**Revised Draft Remedial Action Plan  
and Site Design for Stabilization of  
Moab Title I Uranium Mill Tailings  
at the Crescent Junction, Utah,  
Disposal Site**

**Remedial Action Selection Report**

**June 2007**

This Appendix to the Remedial Action Selection (RAS) Report contains the responses to U.S. Nuclear Regulatory Commission (NRC) comments from meetings held in April and June 2006, to discuss the Draft Moab Remedial Action Plan (RAP). Comments, numbered from each meeting, are stated below along with a response. Comments from the April meeting were related to the topics of geology and seismology, while June meeting comments were related to ground water hydrology, water resources protection strategy, disposal cell design and engineering specifications, vicinity properties, and general interest.

Figure 5-1. UMTRA Project Cover Design and Alternative Cover Design

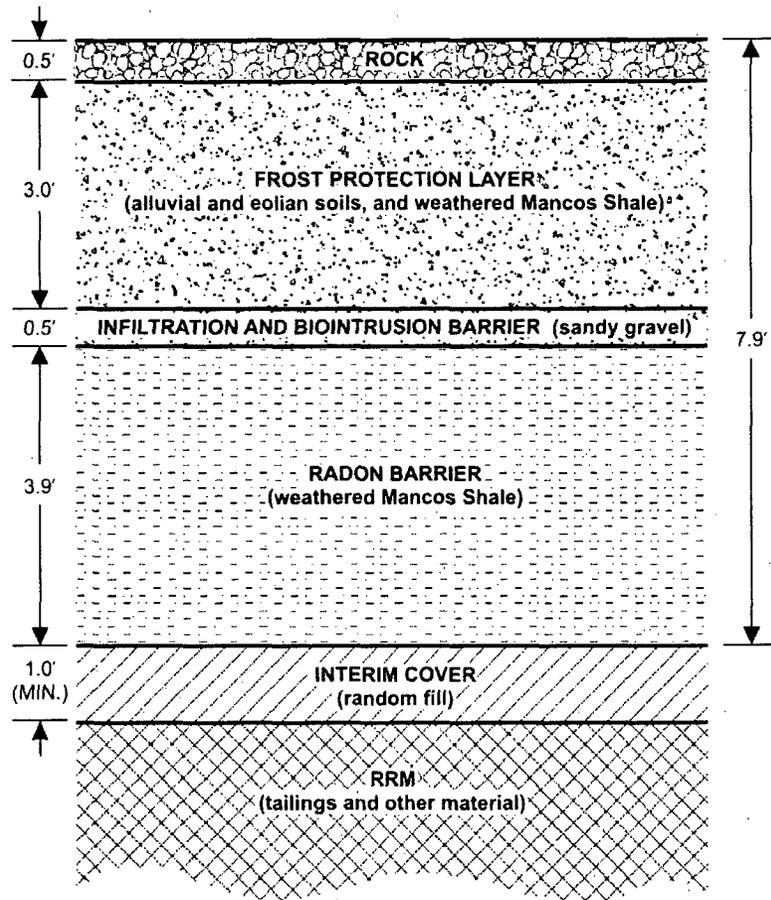
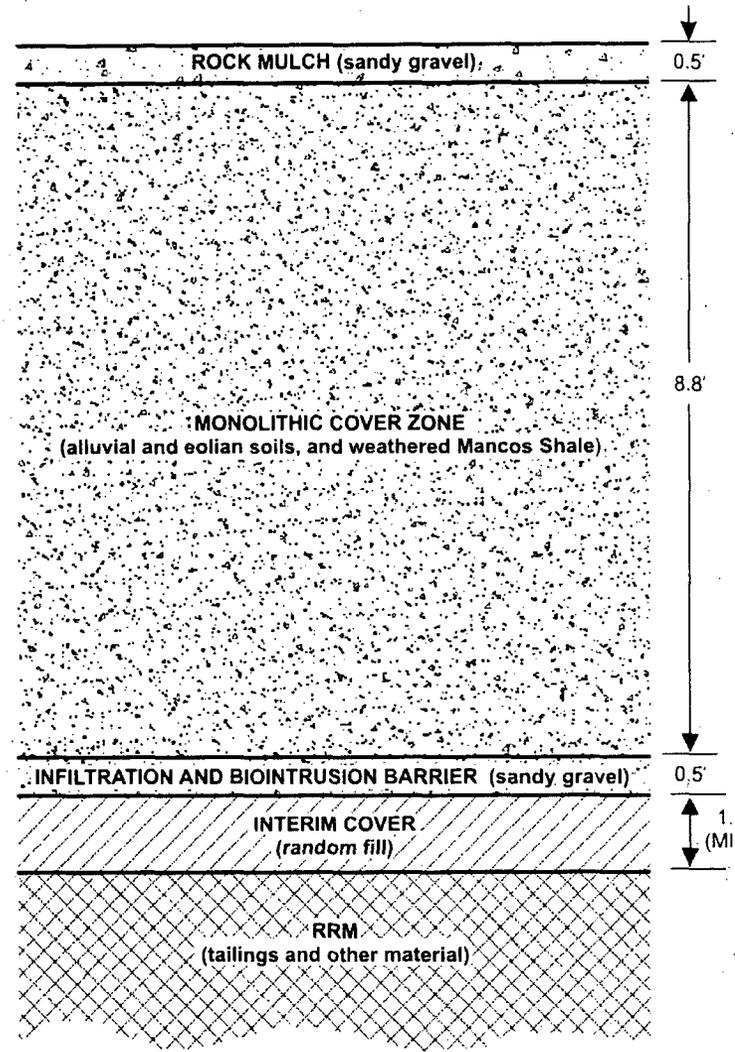
**GT8. Cover Design:** In Section 5.0 and Figure 5-1, DOE discusses and portrays two different cover alternatives, but does not indicate which is planned or preferred. Provide a discussion on the factors that will determine which of the two covers will be used.

Figure 7-2. Disposal Cell Layout with Typical Cross-Section Locations

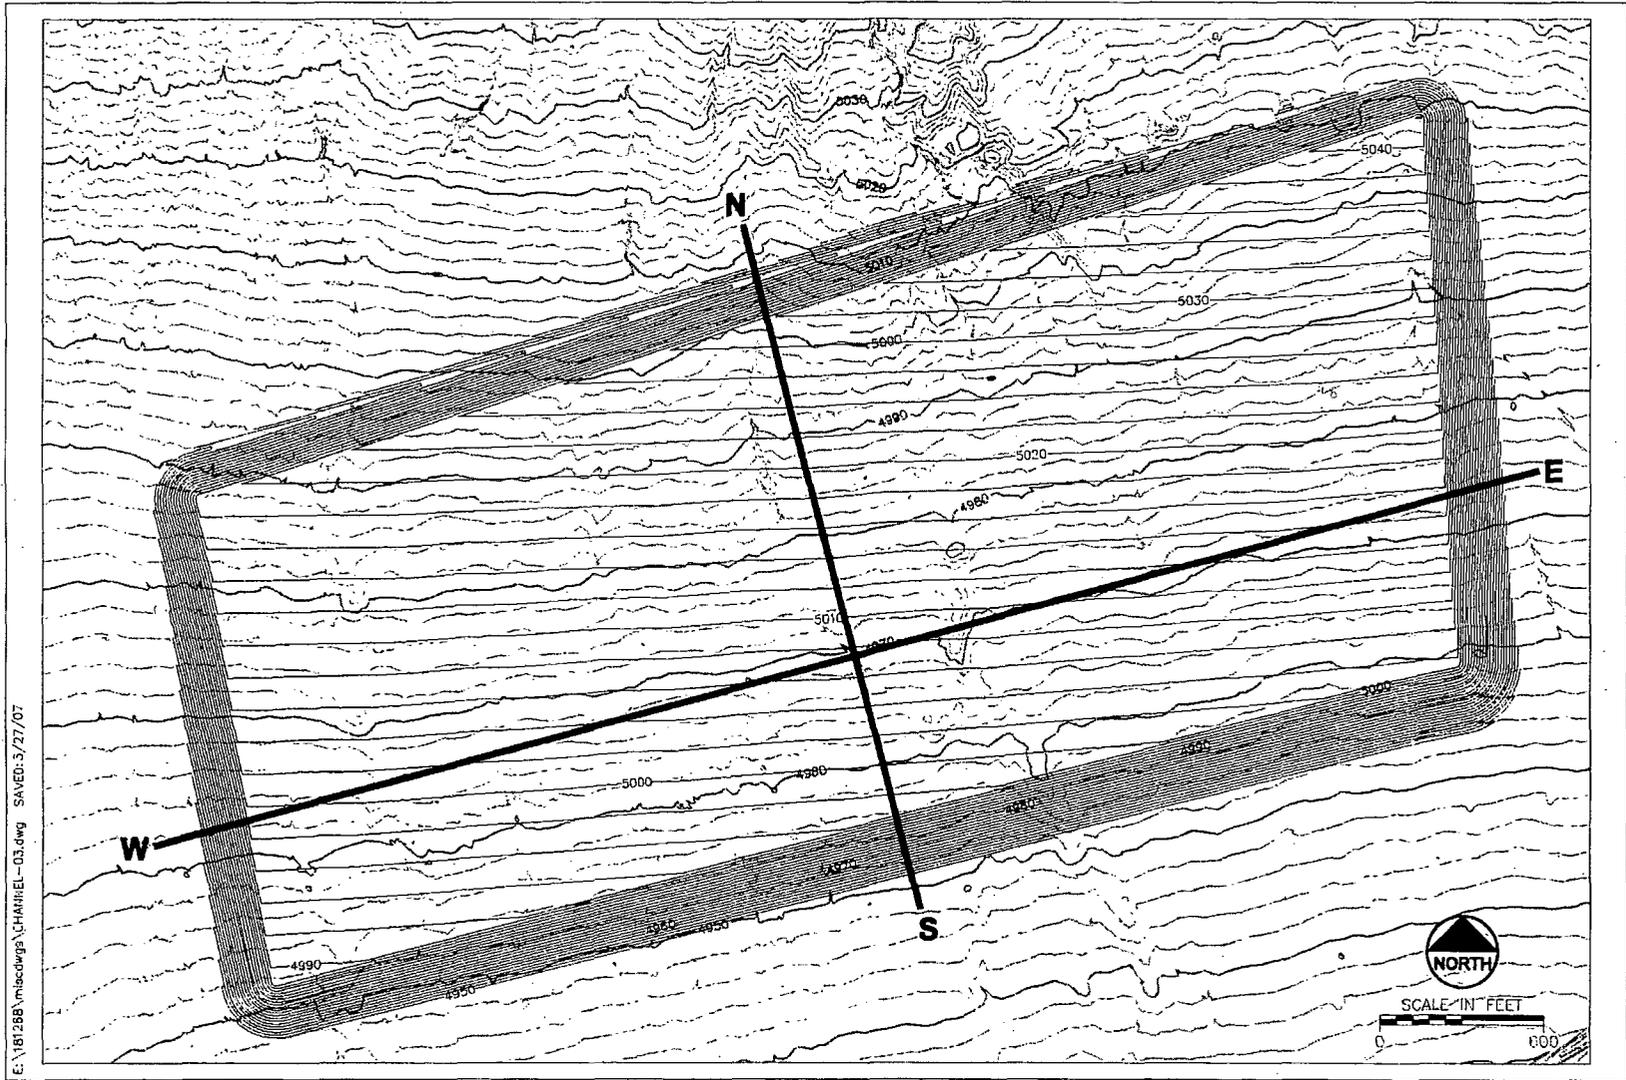
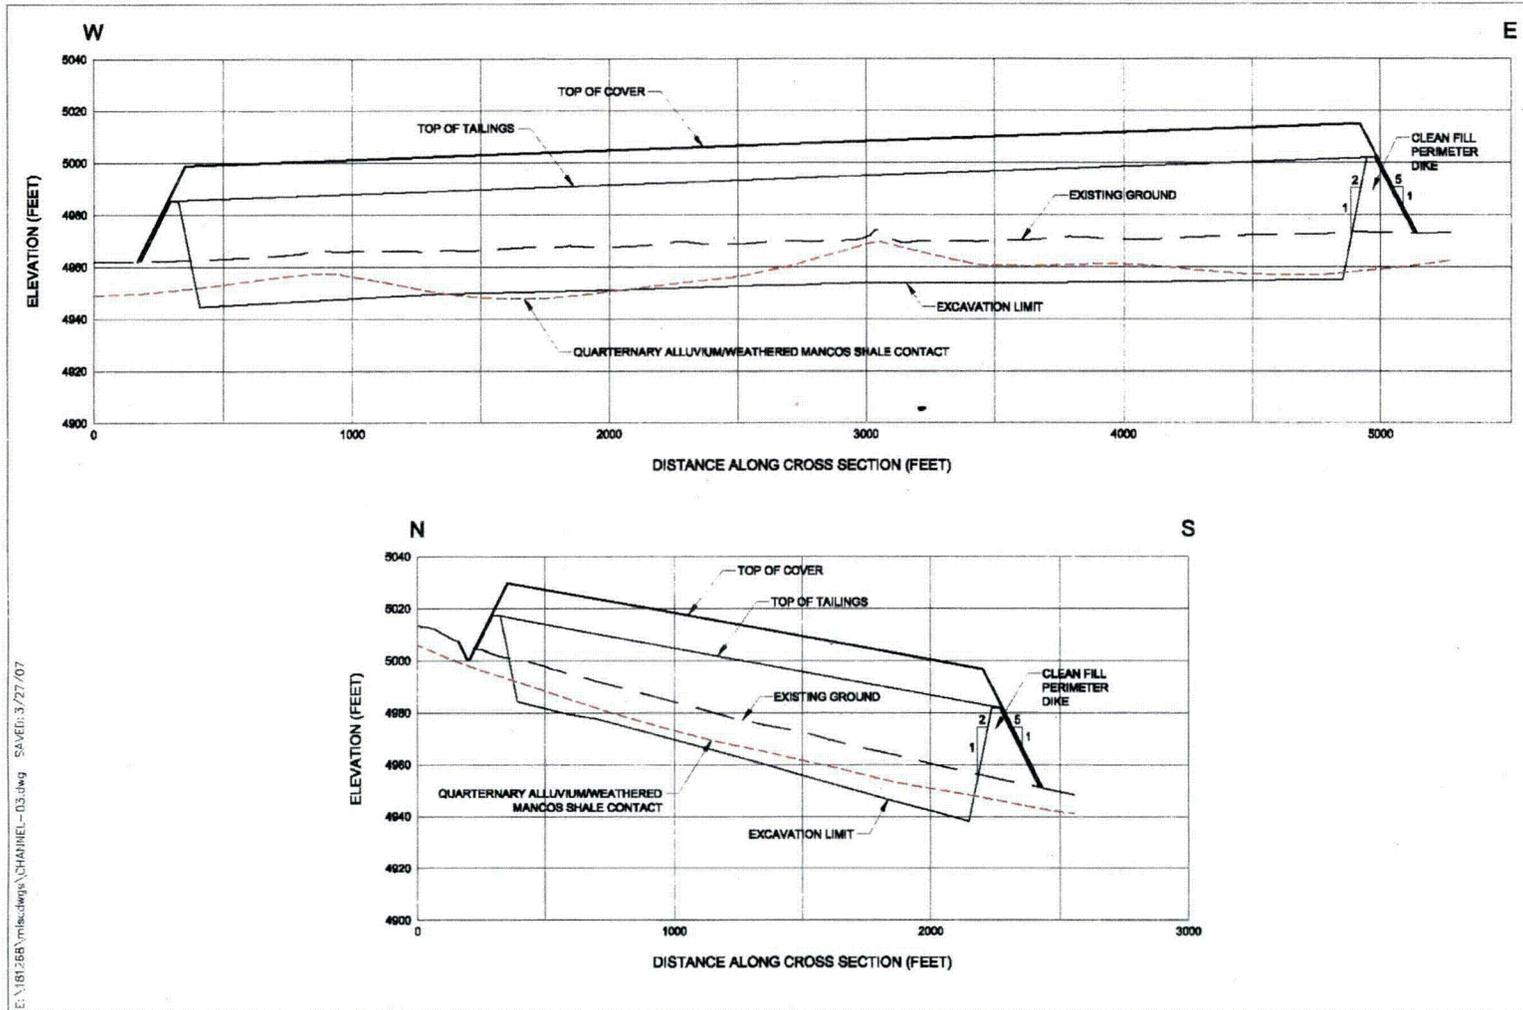
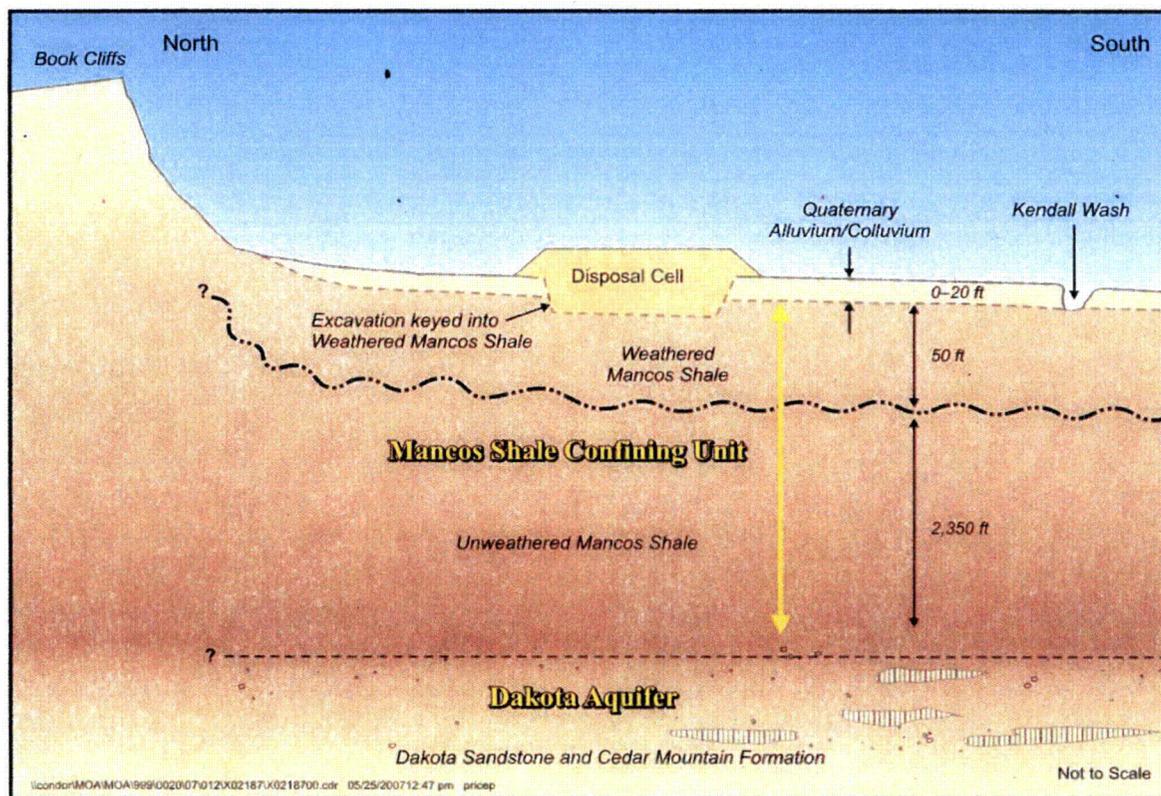
RASR, page 4-3, section 4.1.2. Text in this section indicates "the disposal cell excavation is anticipated to be into the Quaternary materials, as well as into upper portions of the weathered and fractured Mancos Shale." On page 7-1, section 7.0, the text indicates the anticipated depth of excavation is 15 to 20 feet (ft). Figure 7-2 shows the excavation limits as approximately 10 ft below bedrock. Figure 7-3 shows the cell directly on the weathered Mancos Shale contact. It is unclear how far the cell will be placed into the Quaternary alluvial material and/or the weathered and fractured shale. Will the top several feet of weathered shale be removed or will the cell be placed directly on the first contact of the weathered Mancos Shale? The depth of the cell and what material the cell will be placed on should be clearly stated and consistent throughout the Report.

A revised Figure 7-2, a new Figure 7-3, and a revised Figure 7-4 have been inserted into Section 7.0 of the RAS.
